MAGNA ✓ CHEK ^M

SUBJECT: Control Number 77973 - Additional information to Amendment to License Number 21-19111-02 per telephone request by John Madera, USNRC, on April 25, 1985.

FIGURE 1
EXPOSURE CELL

FIGURE 11
EXPOSURE CELL

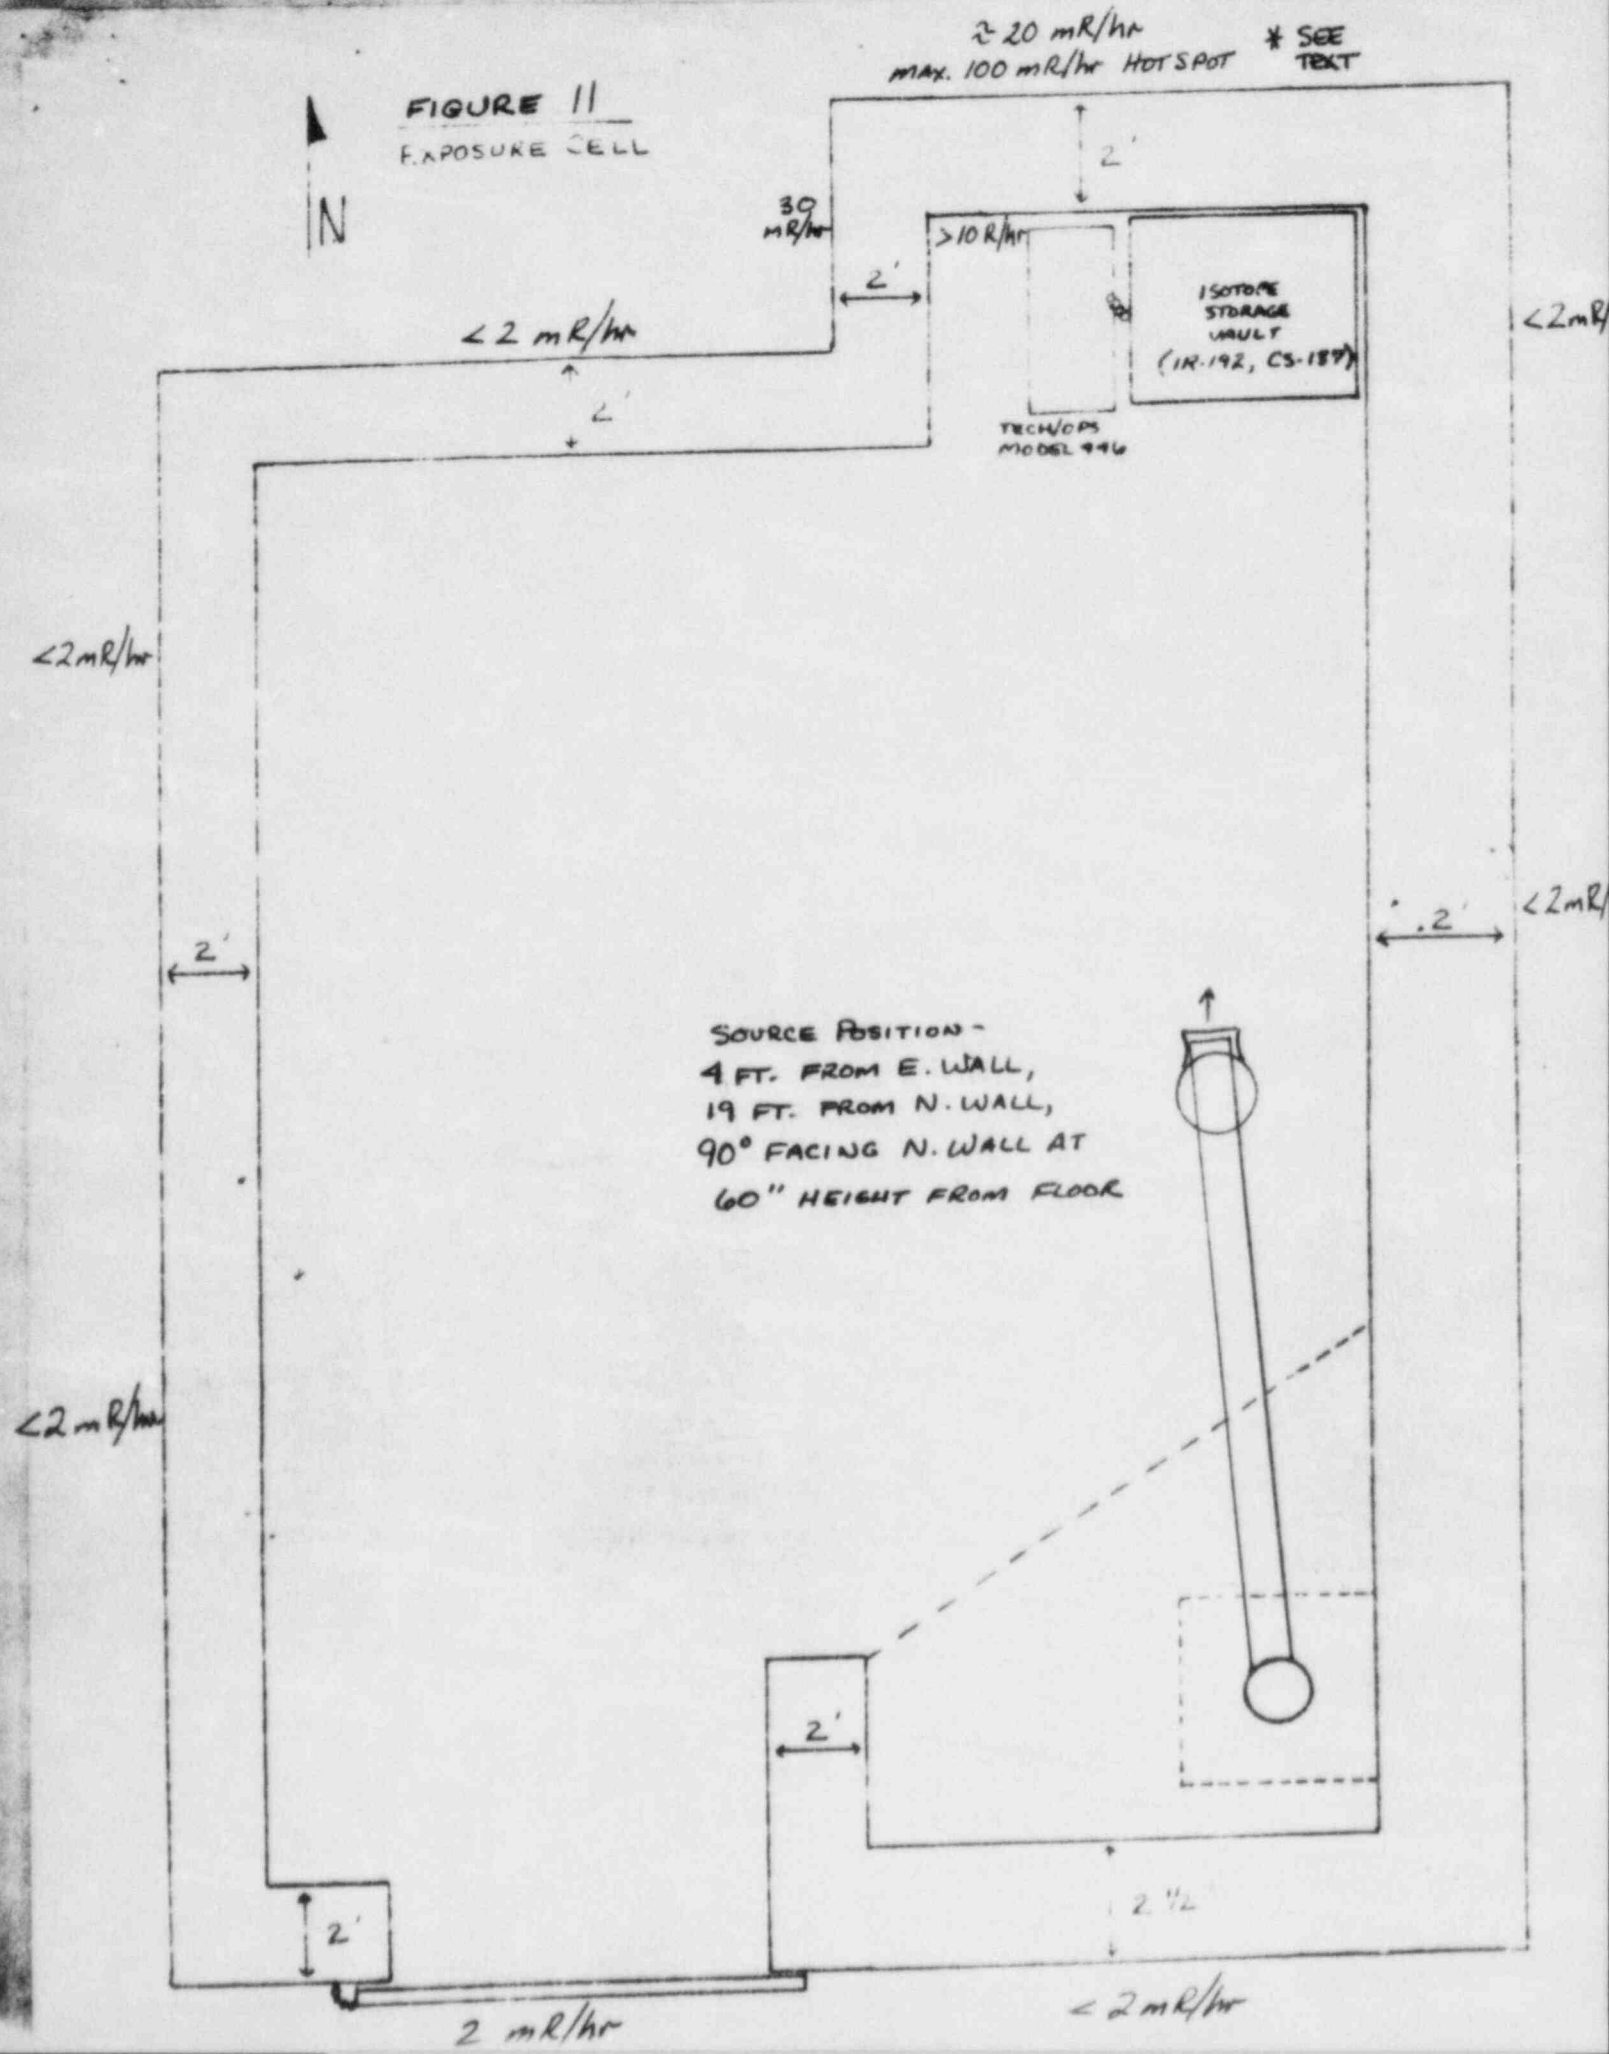
Figure 11 - With the source positioned directly at the north wall at a distance of 19 feet, surveys indicated that radiation levels at external surfaces of the exposure cell did not exceed 2 mR/hr except at the north wall where the intensity was generally 15 mR/hr to 20 mR/hr, with one area measuring .25" x 6" showing an intensity of 100 mR/hr. The source is not used in this position. Note: the radiation intensity at 19 feet inside the exposure cell was in excess of 10 R/hr.

FIGURE 14

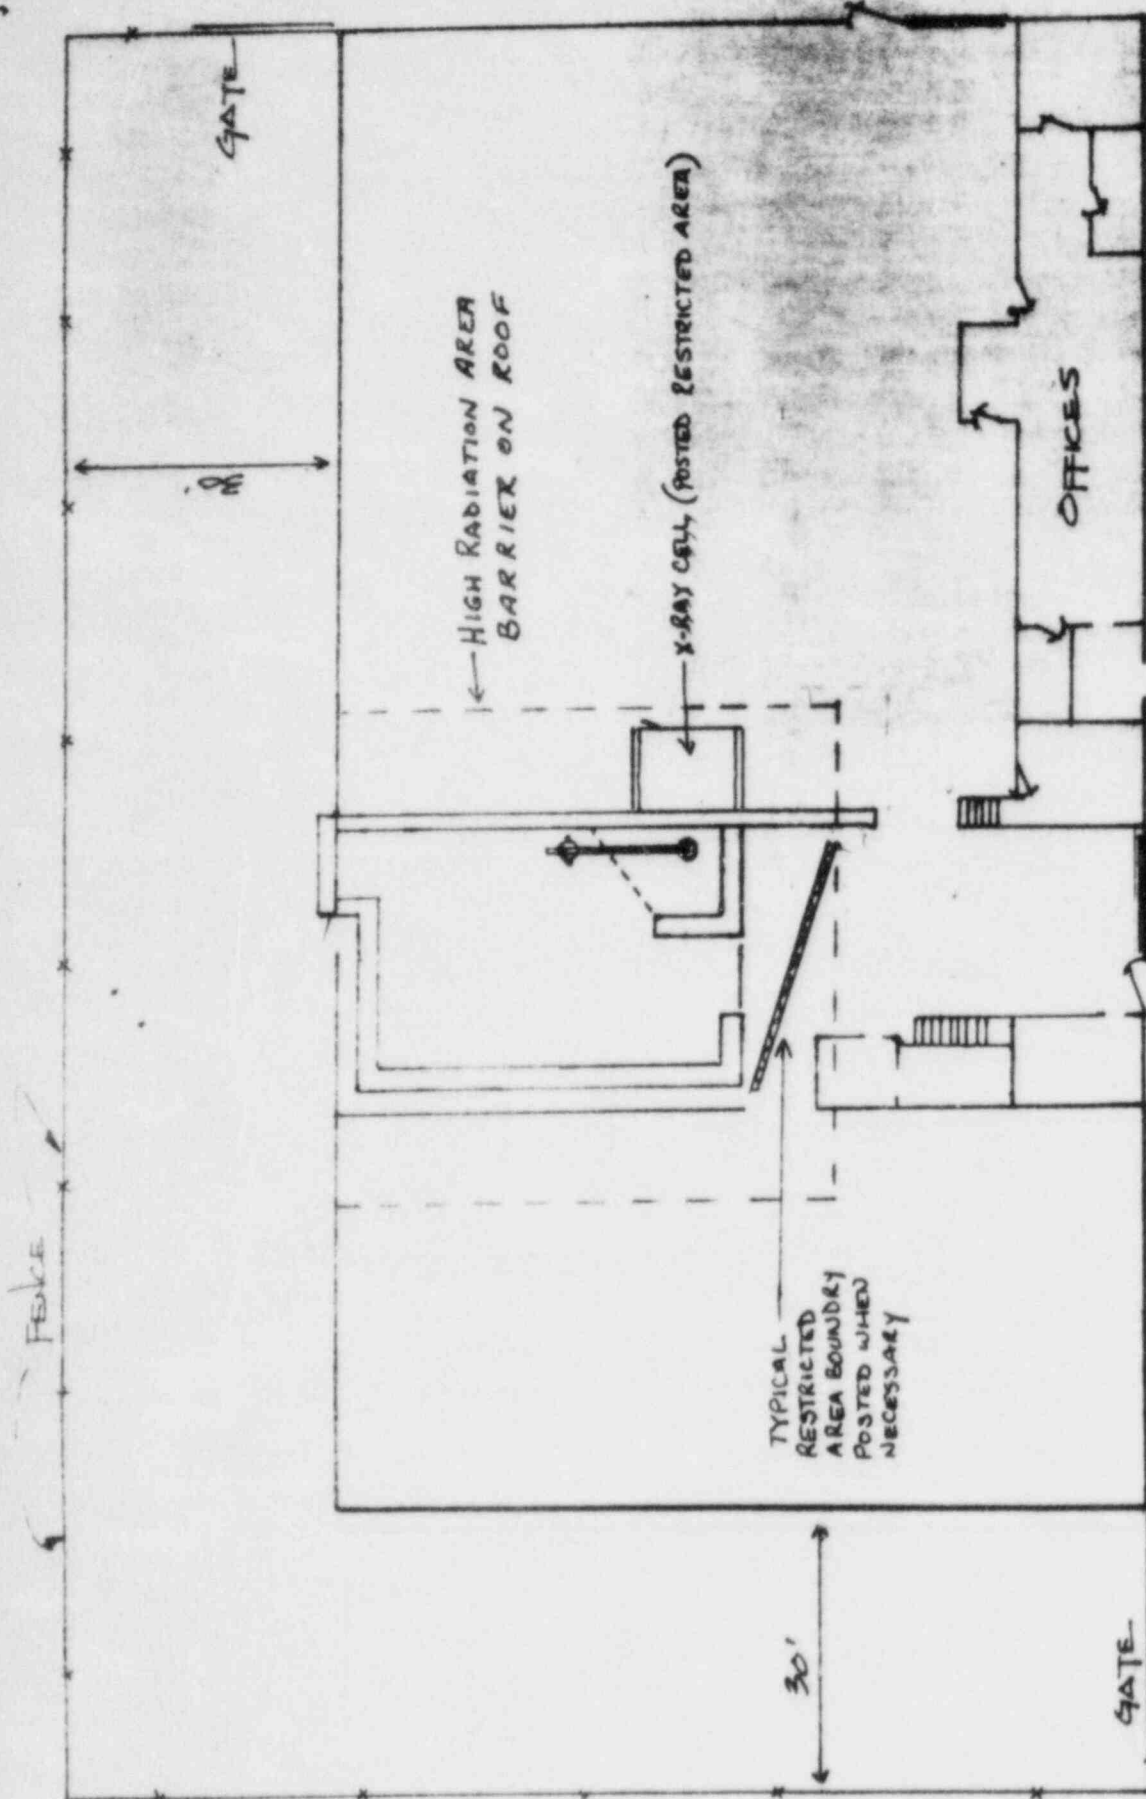
- Figure 5 - Surveys indicated that radiation levels at external surfaces of the exposure cell did not exceed 2 mR/hr with the exception of the south wall directly in front of the source, which showed an intensity of 25 mR/hr. When levels of this intensity are present, the restricted area boundary is adjusted to reflect a 2 mR/hr intensity as shown in Figure 14.

- Figure 7 - Surveys indicated that radiation levels at external surfaces of the exposure cell did not exceed 2 mR/hr except for the exposure cell door which was 35 mR/hr. When levels of this intensity are present, the restricted area boundary is adjusted to reflect a 2 mR/hr intensity as shown in Figure 14.
